Supersession Alternator belt pulley 535 0117 10 by Over-Running Alternator Pulley 535 0105 10

Dacia, Renault

INA 0026

Fig. 3: View of the replacement

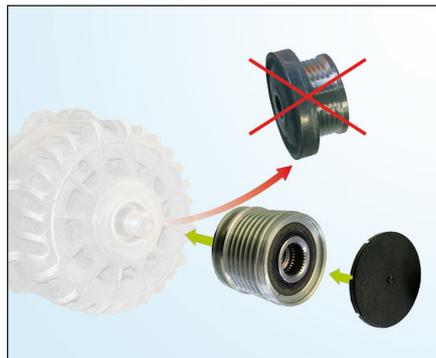
The alternator belt pulley 535 0117 10 (Fig. 1) is no longer available and has been replaced by over-running alternator pulley 535 0105 10 (Fig. 2).

1. Slacken tensioner and remove poly V-Belt
2. Check all belt drive components for damage - replace damaged components
3. Remove the original belt pulley from the alternator (see Fig. 3)
4. Assemble the Over-Running Alternator Pulley **535 0105 10** with the relevant special tool (see Fig. 4)
5. Assemble the seal cap on the Over-Running Alternator Pulley – **Ensuring it is seated correctly and is a tight fit!**
6. Assemble the poly V-Belt
